Access Compliance Report

Public Rights-of-Way

(Curb Ramps)

Intersection ID: 7568	Main Street: LASSEN_BAY_PL	Cross Street: TWEEDSMUIR_GLEN_LN	Location: NW
ADA ID: 951CC17702C5	Ramp Type: BlendTrans1	Initial Pass/Fail: Fail	Overall Compliance: No
Severity Score: 8.75			
Codes/Mitigation Info/Possible Solution		Field Measurements/Component Compliance

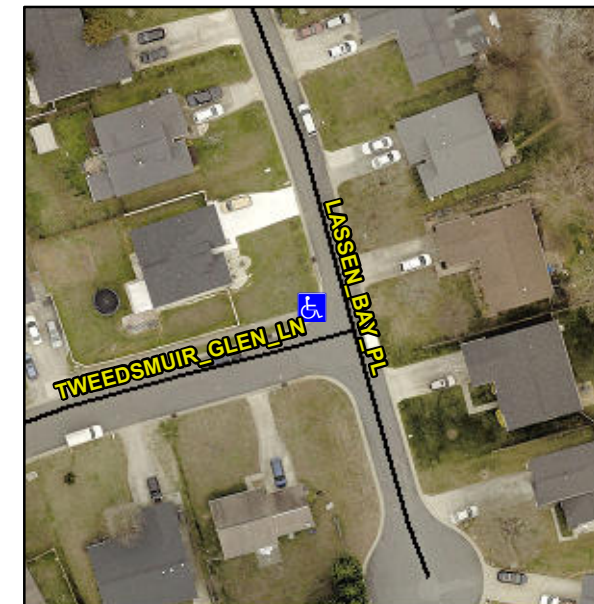
Remove & Replace Curb Ramp With Two New Directional Ramps or Equivalent.

Not Found, R304.5.1
